RIVERDALE CITY PLANNING COMMISSION AGENDA COMMUNITY CENTER – 4360 S. PARKER DR. TUESDAY – AUGUST 9, 2022

Preliminary Site Plan Review: Shake Shack - Riverdale, 4142 South Riverdale Road

Plan Review For Shake Shack

Subj: Shake Shack Improvement Drawing Review

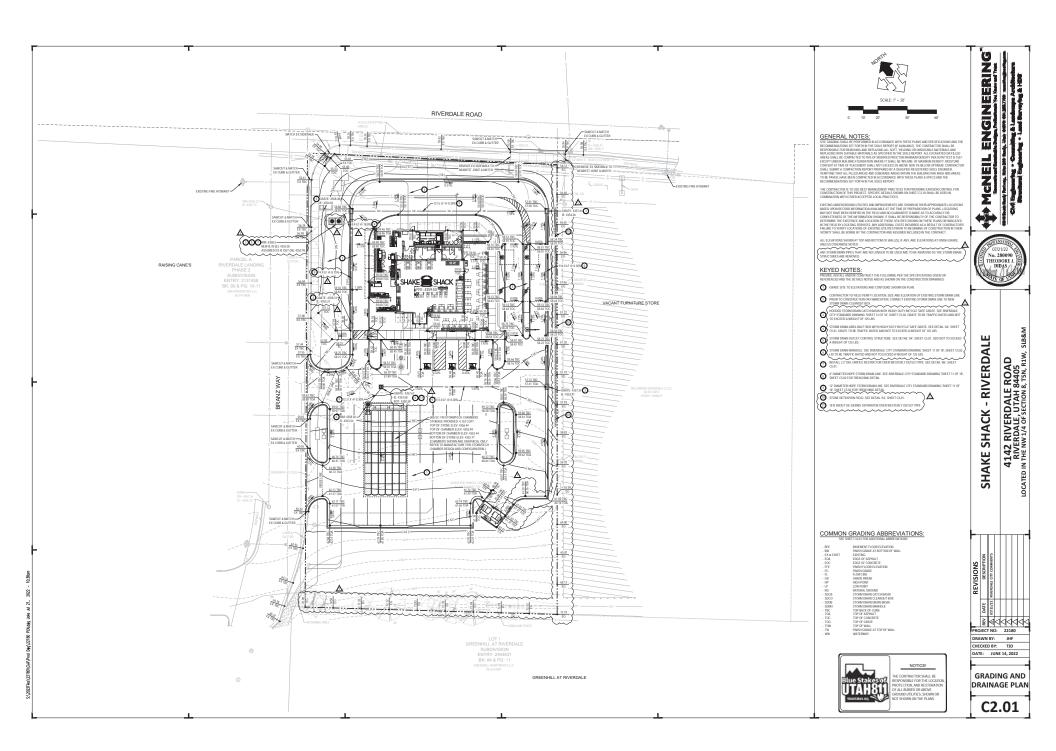
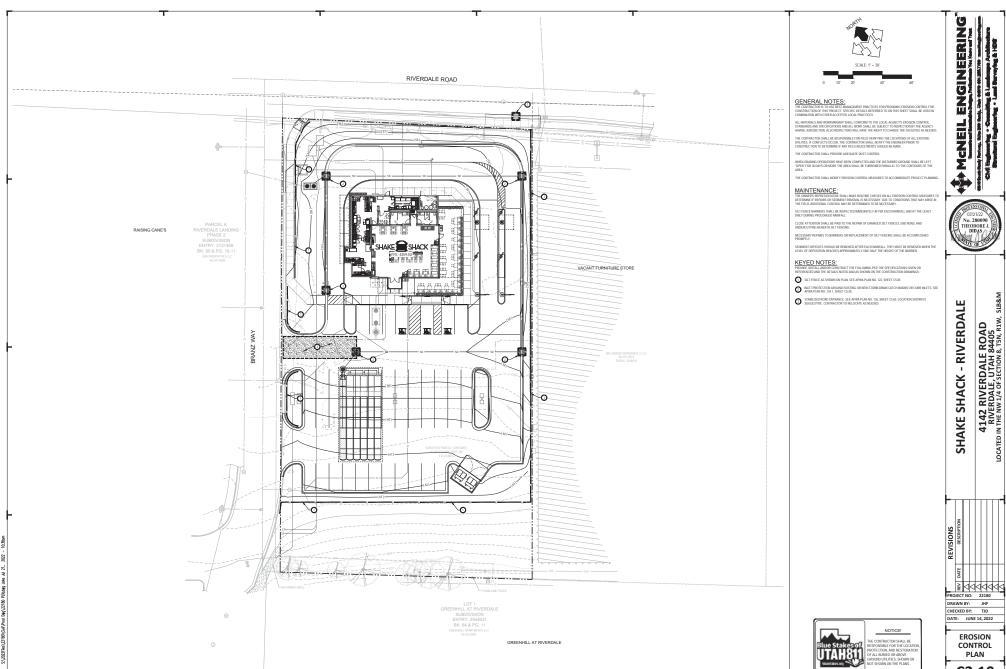
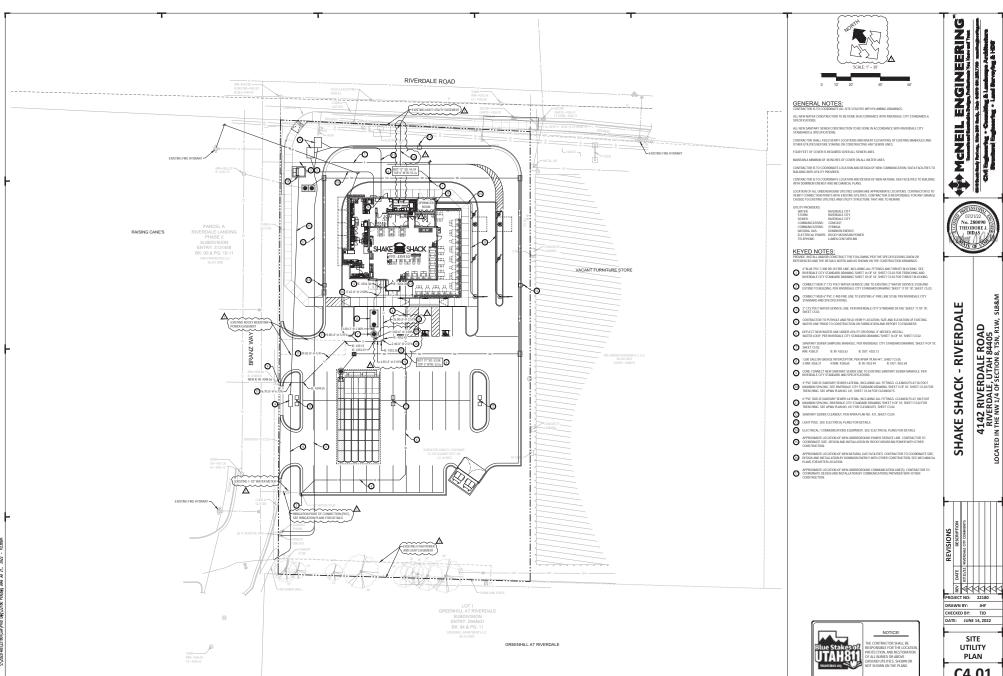
- 1. Directional orientation (North) needs to be corrected on all sheets.
- 2. A Hydrodynamic Separator needs to be added to the storm water system either prior to entrance into the underground storage system or prior to inlet outlet structure.
- 3. An injection well permit needs to be obtained for the underground storage system.

- 4. Snout not shown in any of the storm drain details. Long-Term Stormwater Management Plan refers to the snout for debris control. Hydrodynamic separator will eliminate need for snout and concerns that debris can be flushed past the snout in certain circumstances.
- 5. Show the details for the irrigation connection and backflow device (RP-backflow). Ensure irrigation connection is after the meter.
- 6. On sheet C1.01 it shows removal of "Local Benchmark". Does benchmark need to be replaced?

C3.1

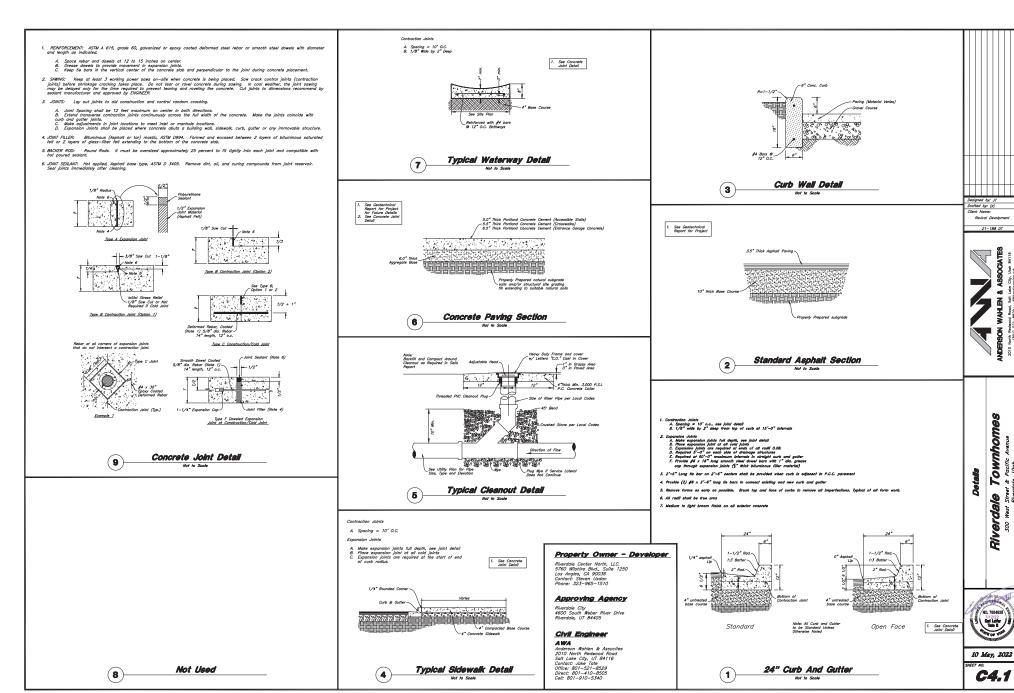
Response: Note has been added to utility plan sheet C3.1.
